Arlo Technologies Inc

Due to the business consideration, we hereby declare that our product of Security Doorbell Model: AVD6001 and AVD5001, AVD6002.

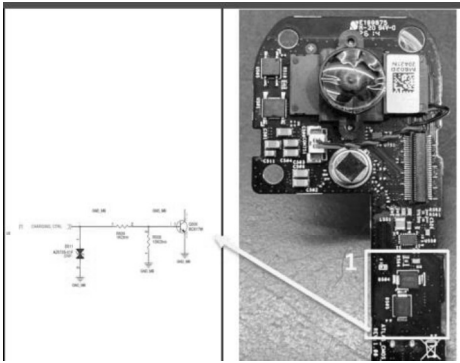
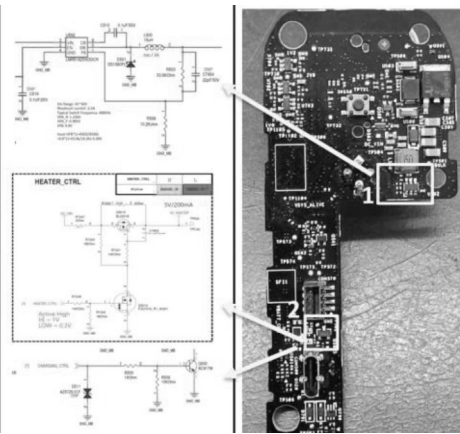
Board PN	AVD6002	AVD6001	AVD5001
Circuitry, components, layout, antenna type and gain	AVD6002, AVD6001, AVD5001 are electrically identical (including RF circuitry, RF components, RF layout, antenna type and gain).		
Circuitry and PCB layout of Main Board	NOR Flash circuit in yellow	All models are electrically identical (including circuitry, components, layout, antenna type and gain).

Circuitry and PCB layout of CMOS Board	Extend the PCB size

Circuitry and PCB layout of CMOS Board	Add 2 EL capacitors.

Circuitry and PCB	Modify the charge control circuit.

layout of CMOS Board			
Circuitry and PCB layout of CMOS Board	1. Change DC-DC converter from MP2459GJ-Z to LMR51625XDDCR for system power requirement. 2. Add Heater control circuit to heat battery on CMOS board and modify charge control circuit. 		
Battery	Arlo A-25 , 700mAh	Arlo A19	
Power source	With existing Electrical wiring AC 16~24V	5 Vdc from Adaptor 3.69 Vdc from Battery	
Video resolution (2K/FHD)	2K 2560 x 1440 video resolution	2K 2560 x 1440 video resolution	FHD 1920 x 1080 video resolution
